Comments on #PSP-26-0004 - Planning & Zoning: Preliminary Subdivision Plat

Application Number: #PSP-26-0004
Application Type: Preliminary Subdivision Plat
Date: September 14, 2026
Address: 408 E YOUNG ST, ROLESVILLE, NC 27571
Parcel: 1768098727

Rolesville Town Campus

PRELIMINARY SUBDIVISION PLAT - SUBMITTAL #1

C-0.00

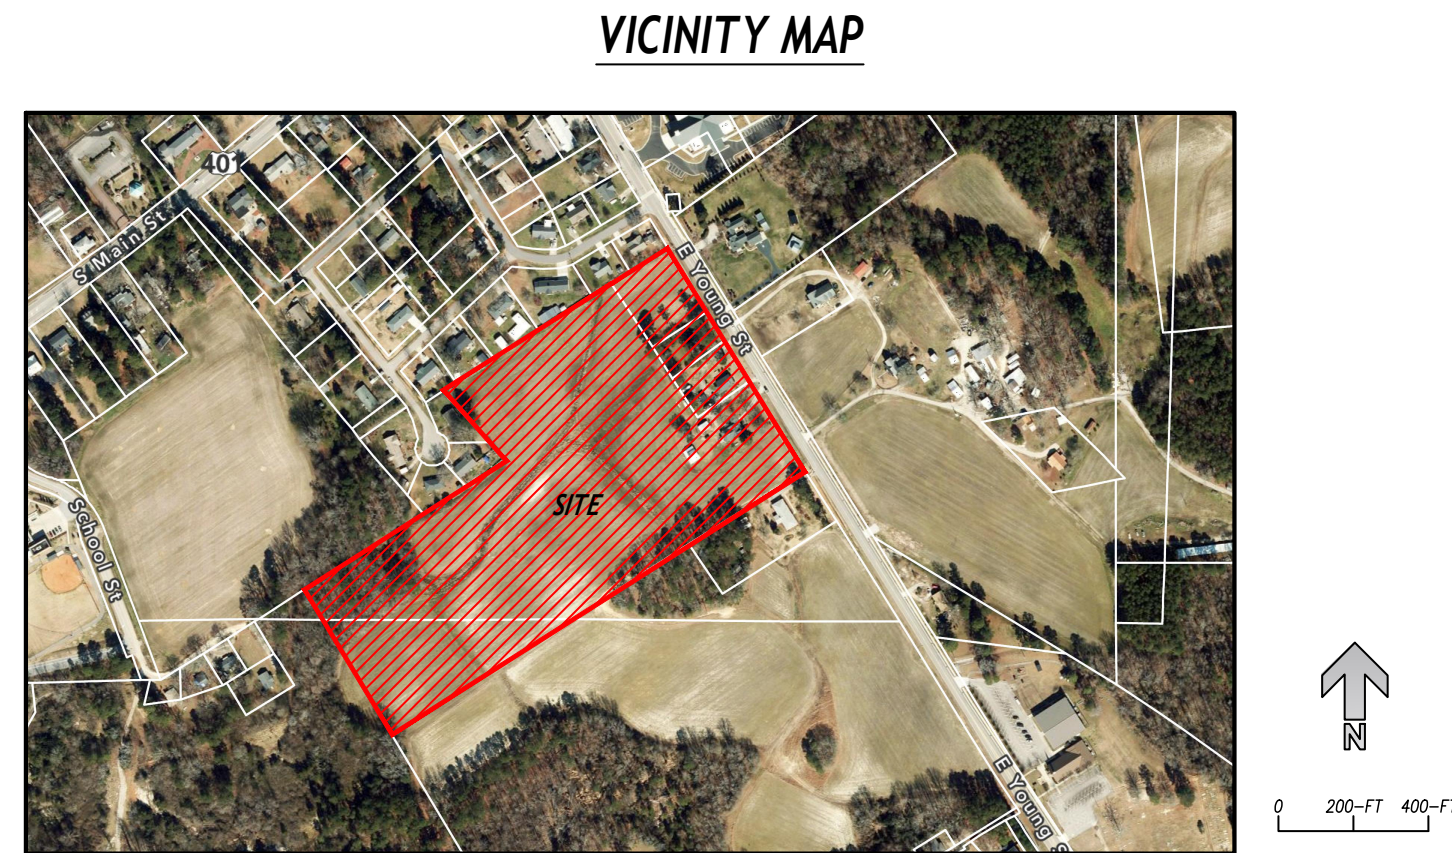
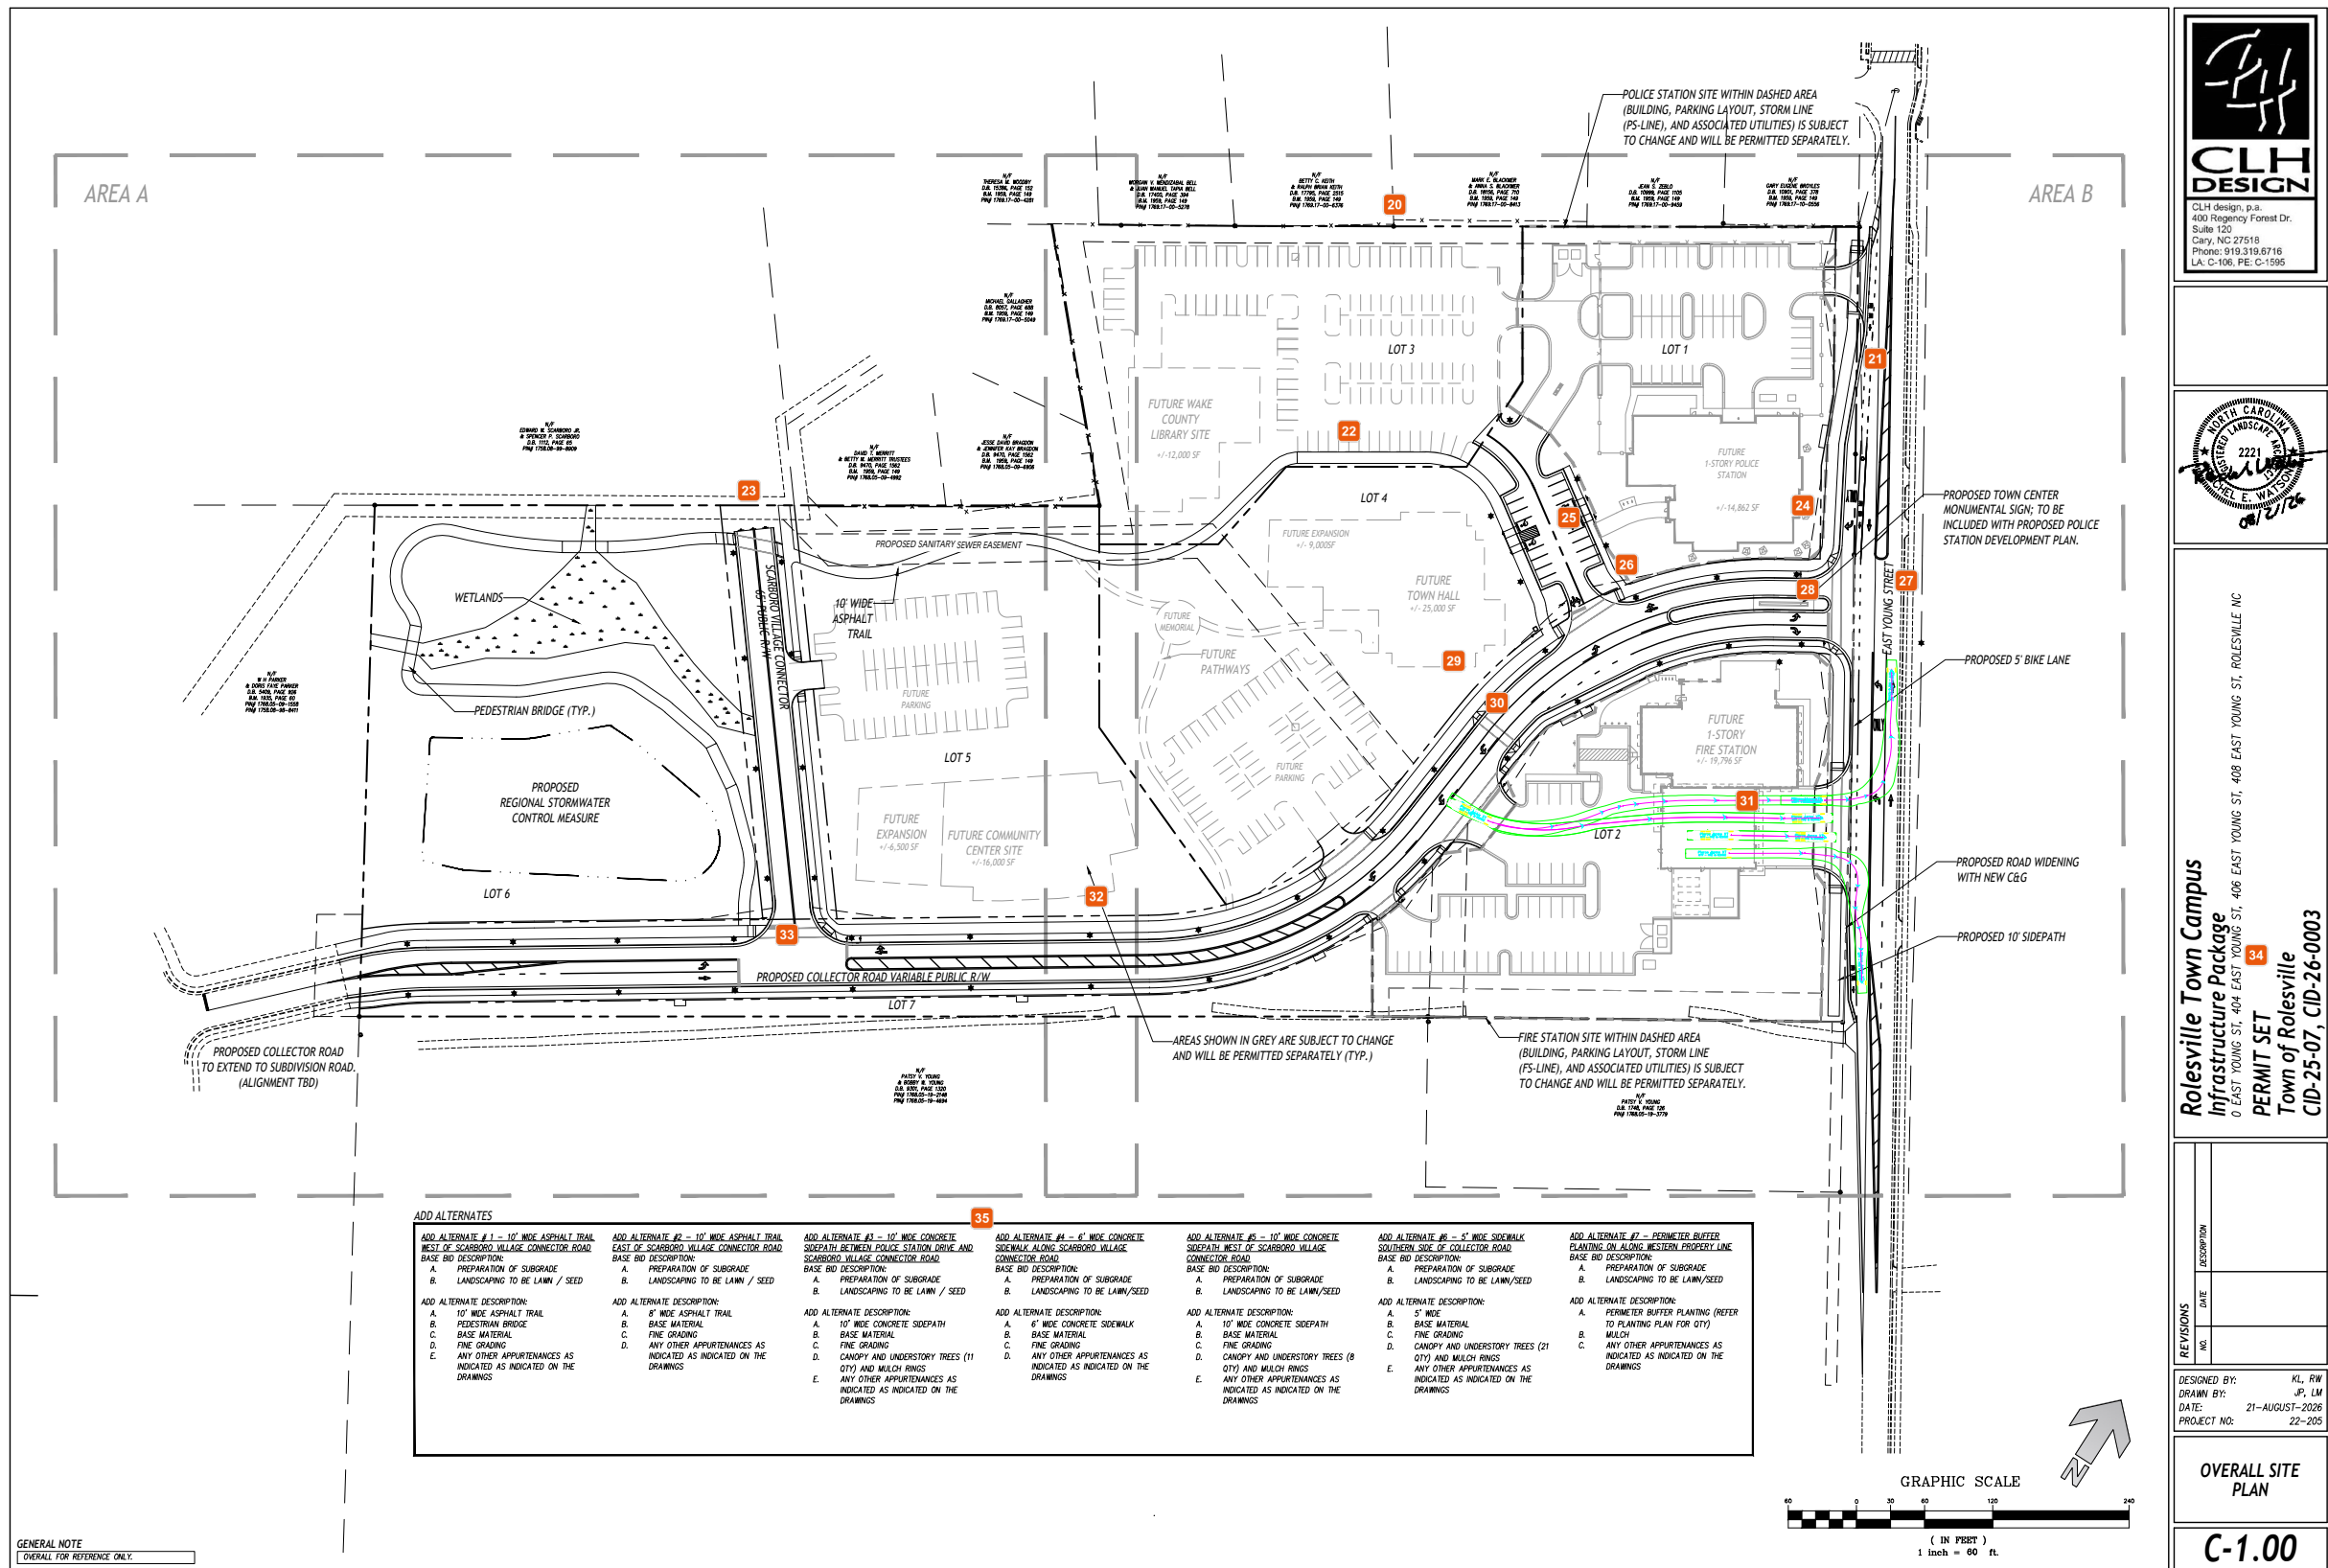
please remove "permit set".

Please add REZ-26-0003, approved 2026.06.16. to reflect current not proposed BT zoning.

Revise the "zoning" and "proposed zoning" Rows per Michele's comment - There should just be a Row for "Zoning" that states "Business, Industry & Technology (BT) District per REZ-26-0003". TY.

Revise the 'Existing Use' Row to "Vacant" as that is the current state.

you can remove these Rows that are "N/A" as staff agrees, they are not appropriate for PSP.

Please correct the typo in the previous entitlements table- REZ was approved on 6.16. TY

LDO Text Amendments are not entitlements. Please delete

For this submittal (preliminary subdivision plat), please remove "Permit Set", "CID-25-07", CID 26-0003/ Raleigh Plan..." - Everything before Rolesville Town Campus.

For this submittal (preliminary subdivison plat), please remove "Permit Set", "CID-25-07", CID 26-0003/ Raleigh Plan..." - Everything before Rolesville Town Campus.
- 16 Stephen Wensman

The site was already rezoned. Zoning should be BT. Remove proposed zoning.
- 18 Stephen Wensman

Text amendments are not entitlements. Please remove.
- 19 Michele Raby
